Project	<b>IEEE 802.16 Broadband Wireless Access Working Group</b> < <a href="http://ieee802.org/16">http://ieee802.org/16</a> >	
Title	<b>Comments on SDD Tile structure in 16m PUSC</b>	
Date Submitted	<b>2009-04-24</b>	
Source(s)	Yang-Han Lee, Yih-Guang Jan, Hsien-Wei Tseng, Ming-Hsueh Chuang <b>Tamkang University (TKU)</b>	yhlepp@yahoo.com.tw
	Youn-Tai Lee, Chun-Yen Hsu <b>Institute for Information Industry (III)</b>	lyt@nmi.iii.org.tw
	Shiann-Tsong Sheu <b>National Central University (NCU)</b>	stsheu@ce.ncu.edu.tw
	Whai-En Chen <b>National Ilan University (NIU)</b>	wechen@niu.edu.tw
Re:	Category: SDD comments / Area: Chapter 11 (PHY)  "Comments on SDD 11 PHY"	
Abstract	Comments on SDD Tile structure in 16m PUSC	
Purpose	To be discussed and adopted by TGM for the 802.16m SDD.	
Notice	<i>This document does not represent the agreed views of the IEEE 802.16 Working Group or any of its subgroups. It represents only the views of the participants listed in the "Source(s)" field above. It is offered as a basis for discussion. It is not binding on the contributor(s), who reserve(s) the right to add, amend or withdraw material contained herein.</i>

# Comments on SDD Tile structure in 16m

Figure 1 Tile structure in 16m PUSC

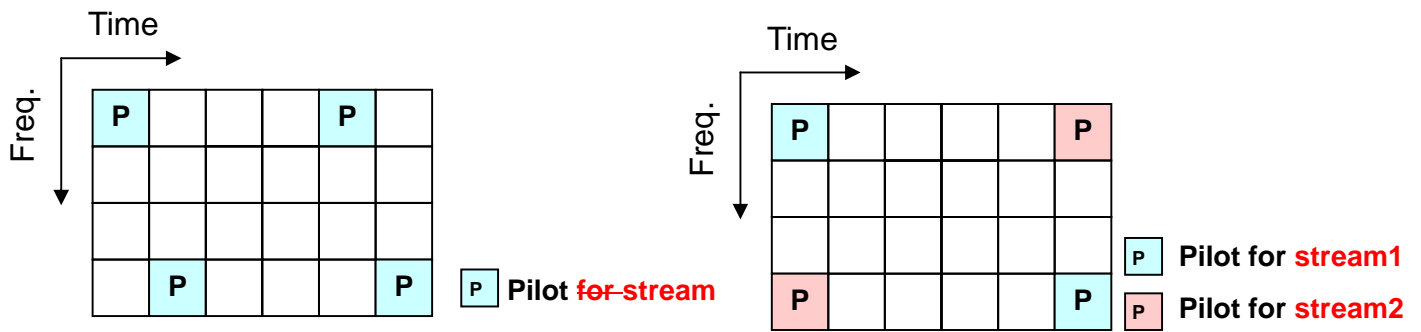
This contribution provides the corrected SDD text proposal to Distributed Resource Unit for 16m PUSC. In Figure 48, it has some errors and has been corrected.

[In IEEE 80216m-08\_003r8, Section 11.6.4.1, Replaced by the following corrected text]
